SITE: 245-275 Lamarche Ave

TITLE: Geometric Road Design
Redline

SCALE AT A3: NTS	DATE: 2022-07-19	DRAWN: BB	CHECKED: AL
PROJECT NO: 2022-023	DRAWING NO: 001	REVISION: 02

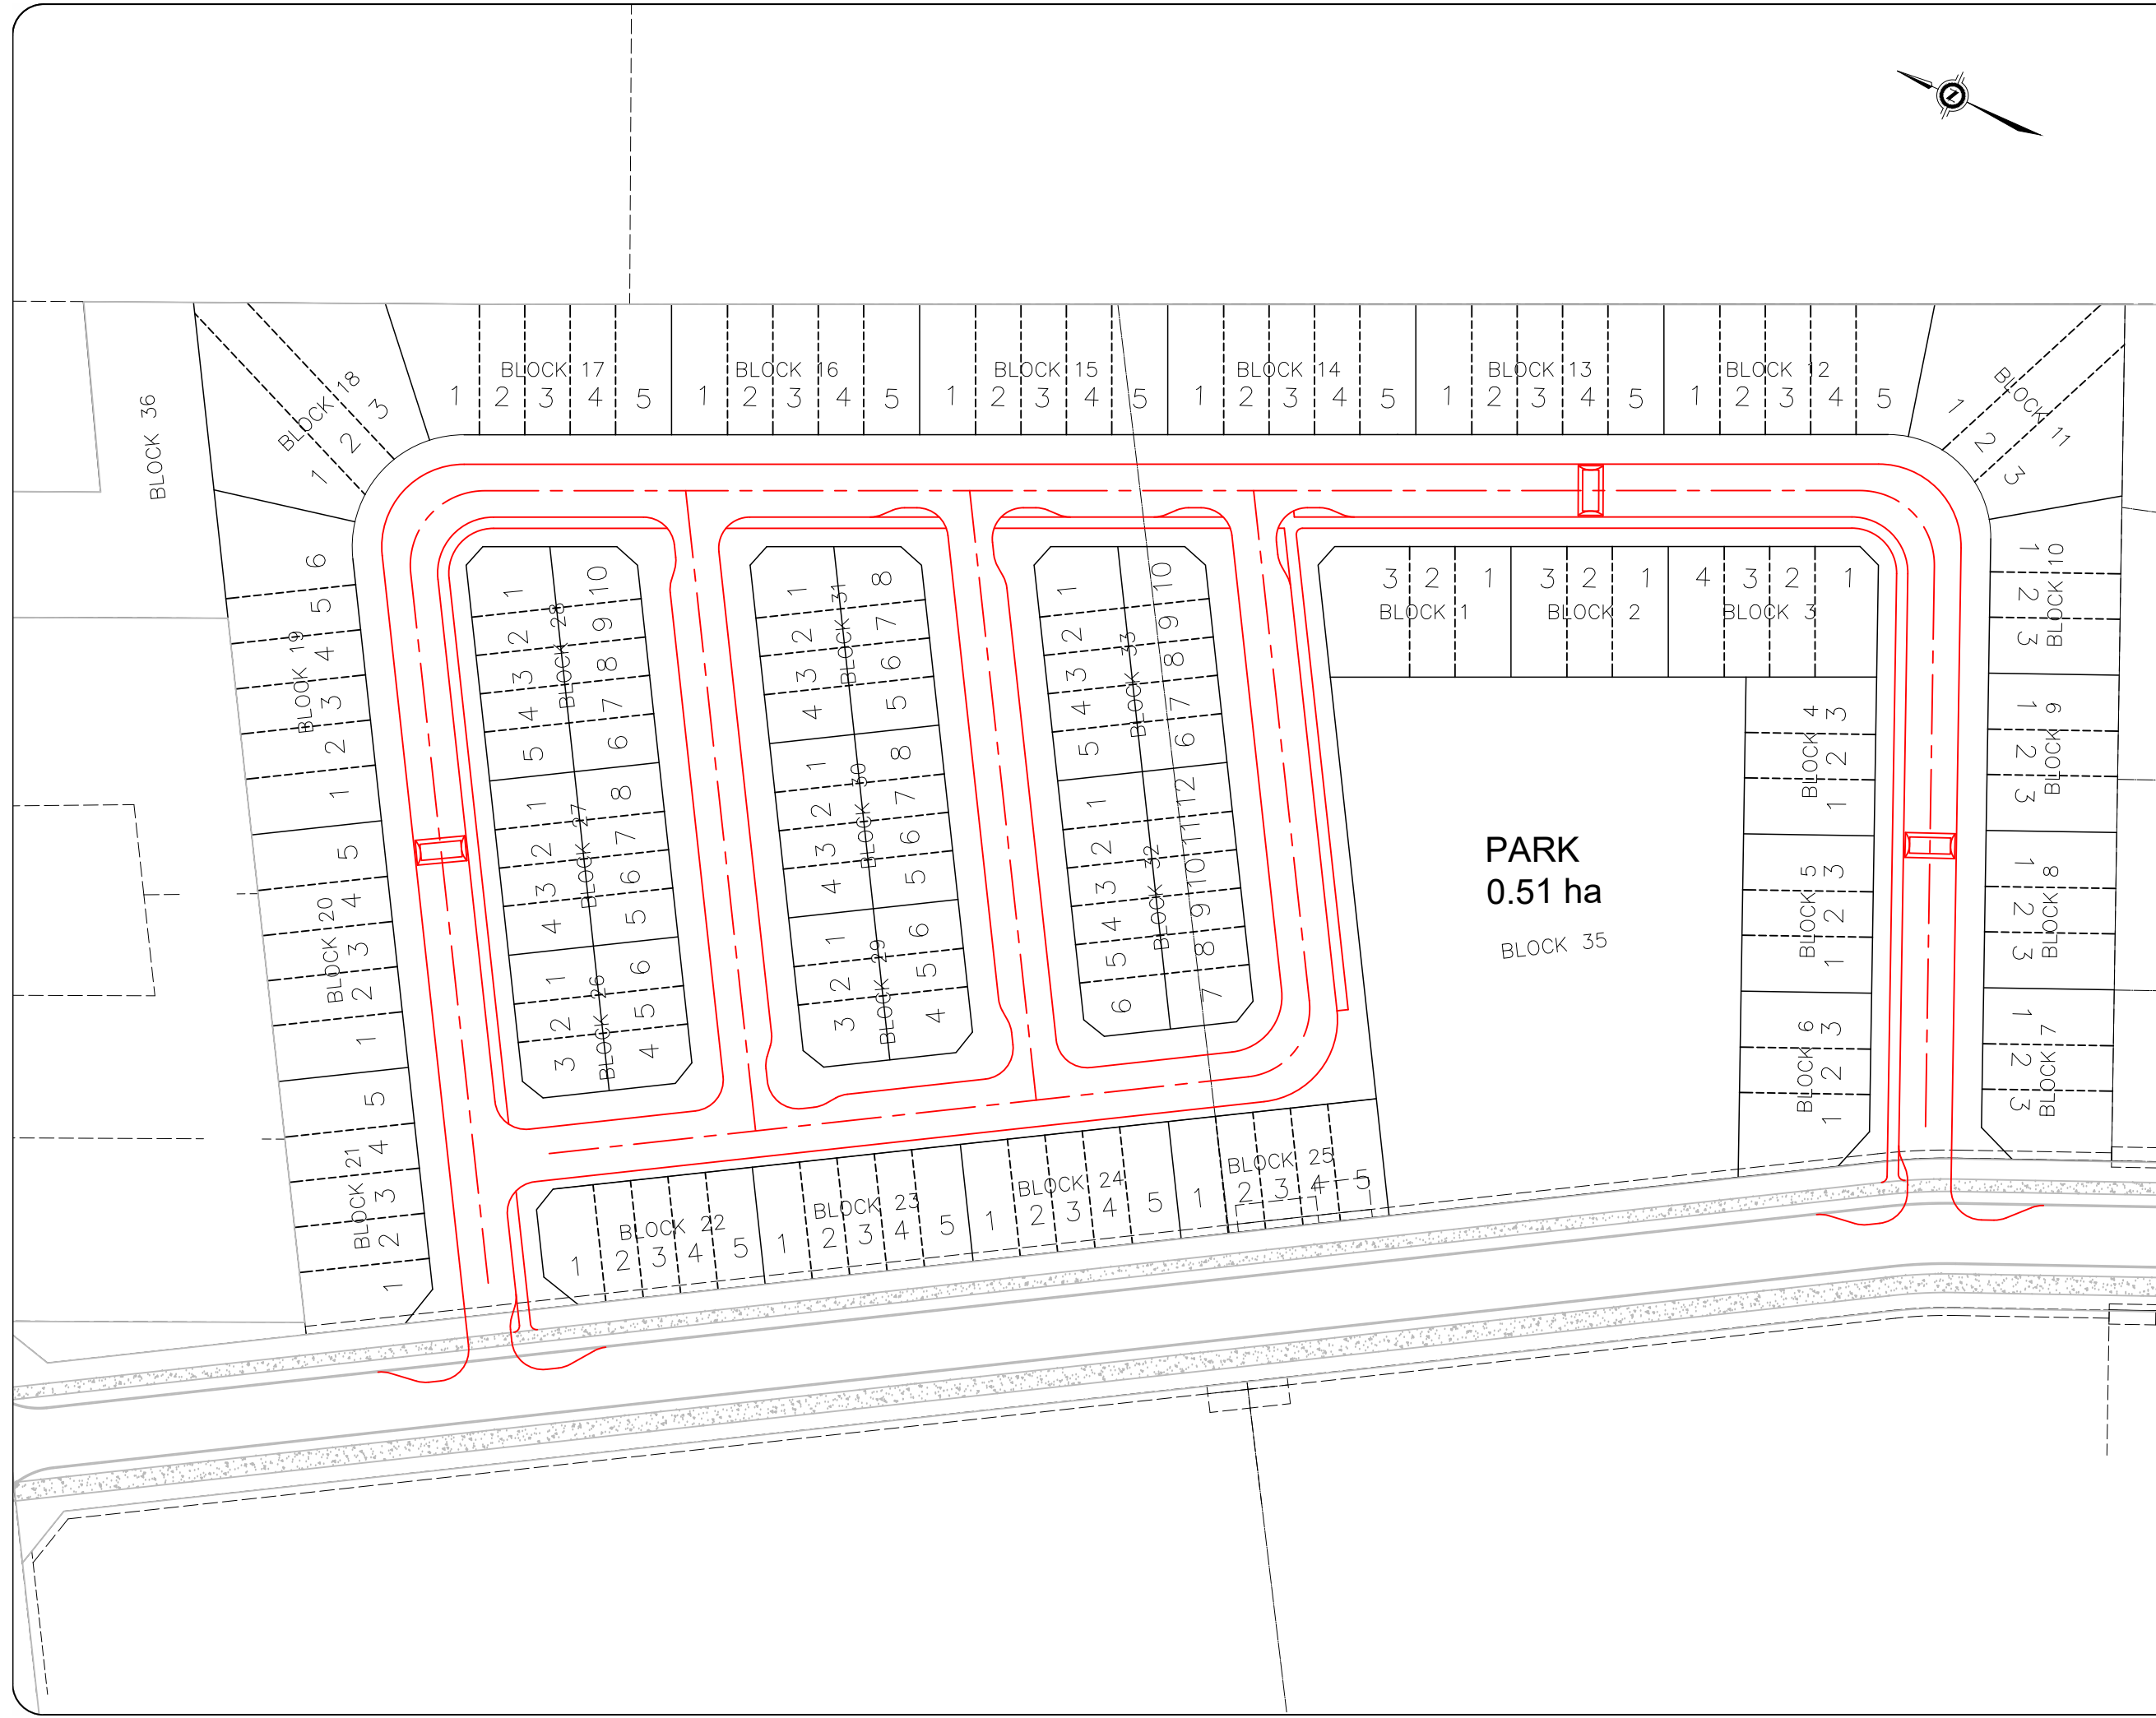
02	Updated Site Plan	BB	2022-07-19
01	Issued for Review	BB	2022-04-12
REV:	DESCRIPTION:	BY:	DATE:
STATUS:
